Purpose for Service Bulletin

The **updated** gasket has improved sealing of fuel vapors and improved compatibility with fuel that contains ethanol alcohol additives.

Figure 1. 61381-02A - Top Plate Gasket

Figure 2. Top Plate Torque Sequence

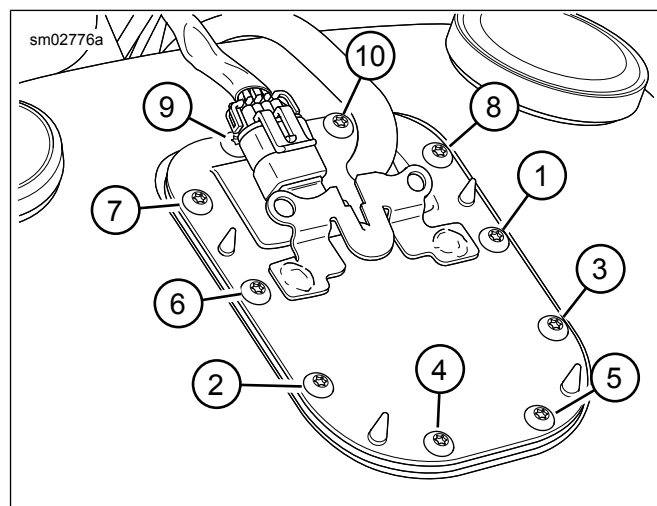
5. Refer to Figure 2. Install **new** screws. Tighten per sequence.

Torque: 2–2.7 N·m (18–24 in-lbs)
